REQUEST FOR REVIEW 17/0007/LRB

Comment with regard to: Amendment of Condition 2 of Planning Permission 17/01092/PP dated 10/10/17

PROPOSED DWELLING FOR WILLIE BEATTIE @ KILMEFORD, ARGYLL.

SITE & PROXIMITY PLAN

Arch plan was amended and duly approved by Planning department.(enc)

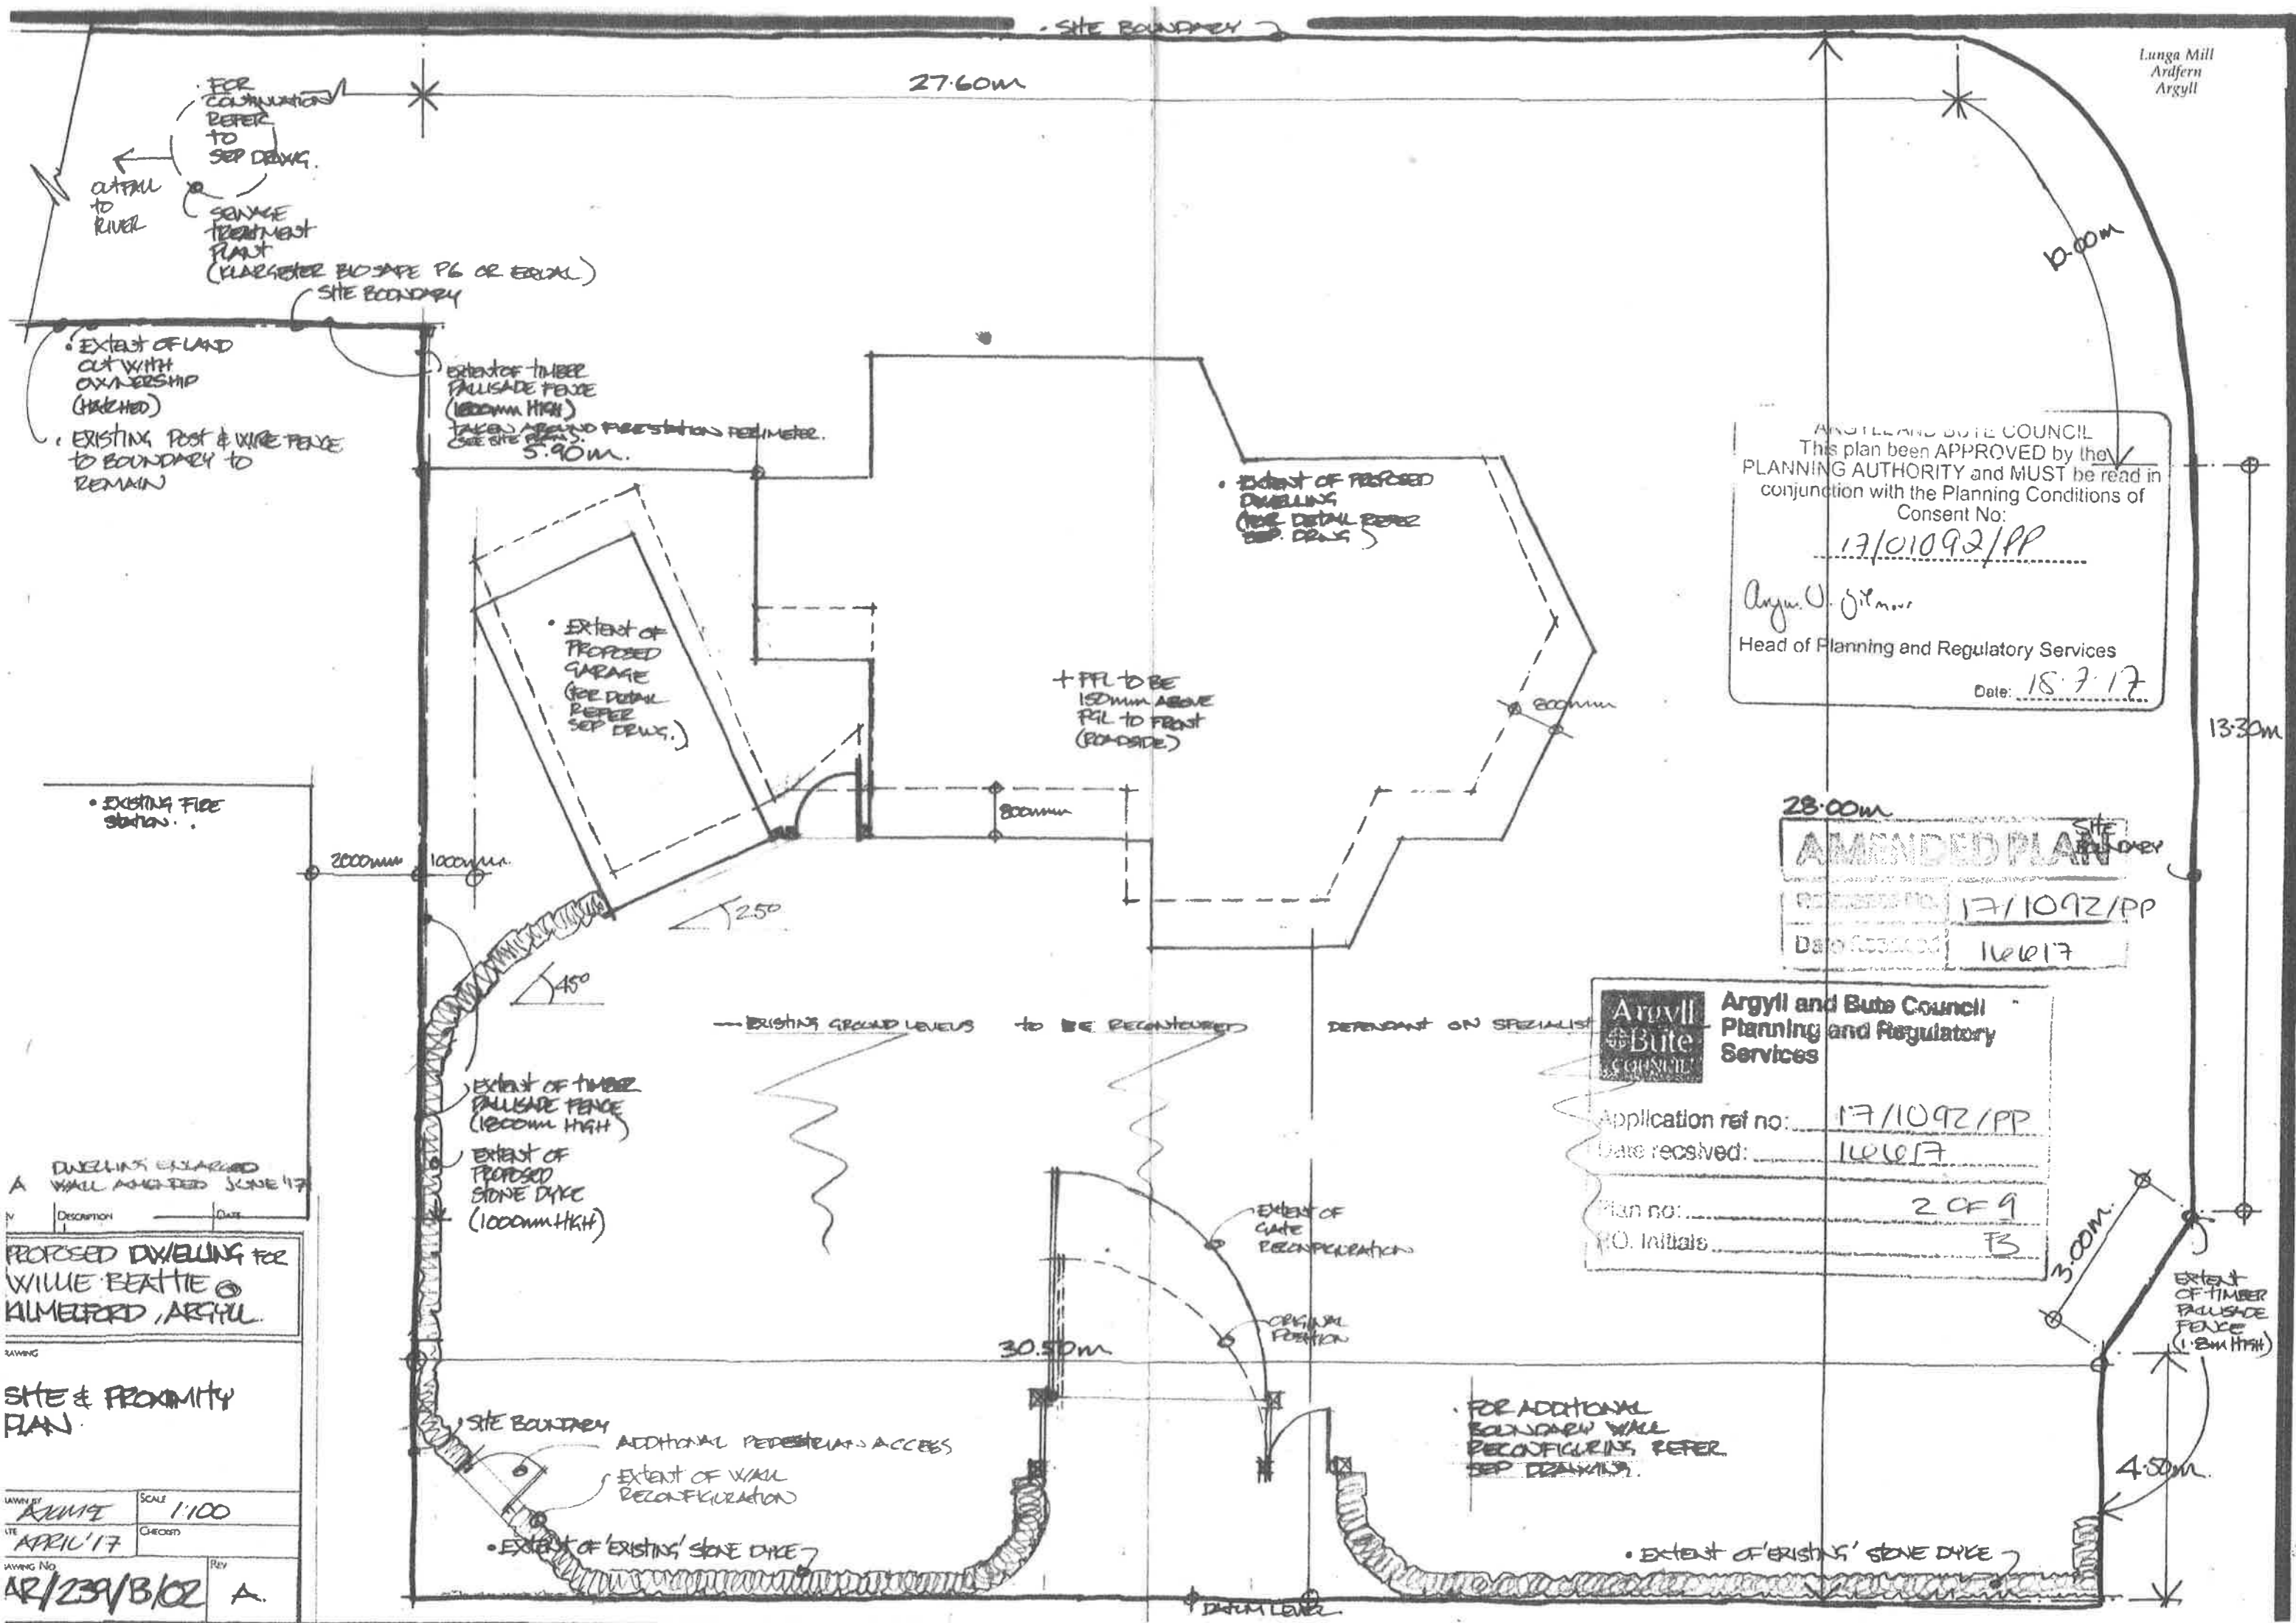
Extent of Adjacent service bay accepted by Brian Rattray and confirmed by Stuart Watson as being acceptable for use with Application site (copy of email enc). Modification was agreed to wall to site to allow pedestrian access from this point.
